# Service Bulletin

NO. 353

## SERVICE CORRECTIONS - 1960 MODELS

FIG. 2

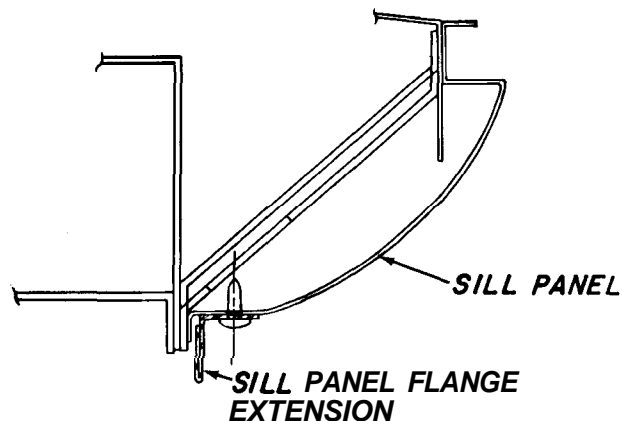
## SILL PANEL FLANGE EXTENSION - 1960 Convertible Models

1. Prime and paint the new sill panel flange extensions to match the body color.
2. Place the flange extensions next to the body sill lower flange with the attaching holes upward (see Fig. 2) and with the rear of the extension flush with the rear of the sill panel flange (see Fig. 1).
3. Starting from the front, drill the sill panel at the 1st, 2nd, 4th, 6th, 9th, and 10th holes in the extensions. Use a 1/32 or 7/64" drill and secure the extensions to the sill panels with Part No. S-161857. sheet metal screws.

FIG. 1

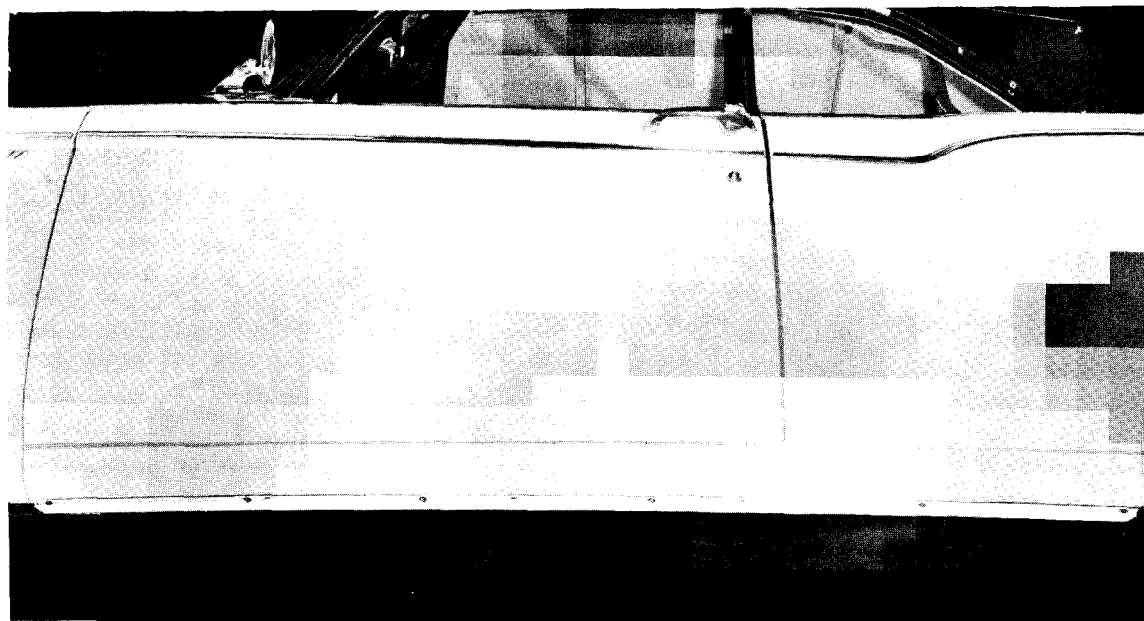
Beginning with passenger car Serial Numbers, 60S-45256 and 60V-36305 Sill panel flange extensions are used on 1960 Model convertible cars (See Fig. 1). These sill extensions improve the appearance of the convertible models, by covering the welds along the lower edge of the body sills.

The sill panel flange extensions (2 required per car) may readily be installed on models prior to the above serial numbers. The following parts, available from your Parts Depot, are

- 2 Part No. 1337324 Sill Panel Flange Extension
- 12 Part No. G-161857 Attaching screw

FIG. 3

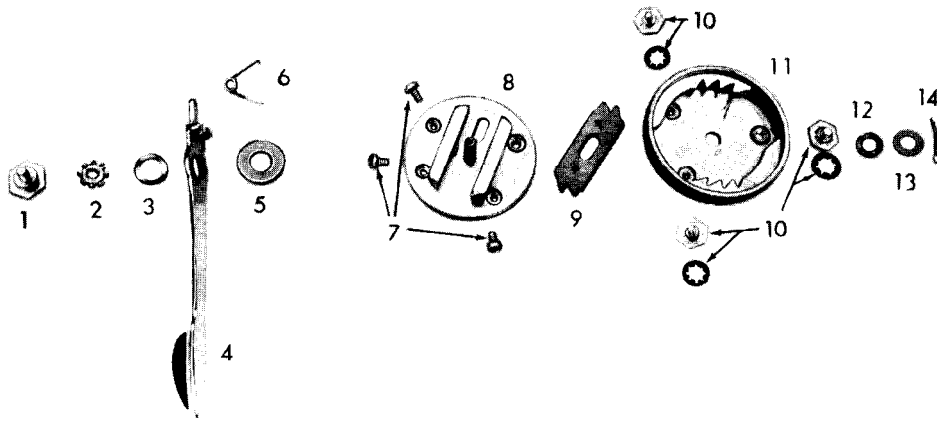
## RECLINING SEAT MECHANISM

Erratic operation resulting in excessive wear of the internal gear teeth can be caused by the backing plate and internal ring gear housing separating sufficiently to allow only partial engagement of the gear teeth.

Operating lever working loose allowing the lever to override the operating pin on the Shuttle gear making the mechanism inoperative.

1. The upper and lower seat frame brackets for the reclining seat mechanism must be exactly parallel. Carefully bend brackets as required to make them parallel.
2. Remove any accumulated paint from the external surfaces of the ring gear housing and the backing plate so that the ring gear housing seats properly.
3. A few early production seat mechanisms were assembled with a **11/32"** flat washer located on the backing plate pin next to the cotter key. In some instances this washer will allow the retaining cotter key to pull part way through the washer.
4. Install new ring gear housing and related parts as required, being sure to use **5/8"** backing plate pin retaining washer, Part No. G-120386, and a new **3/32" x 1"** cotter key.

Remove lever and reinstall using an external tooth lock washer, Part No. G-121753, rather than an internal tooth type lock washer.
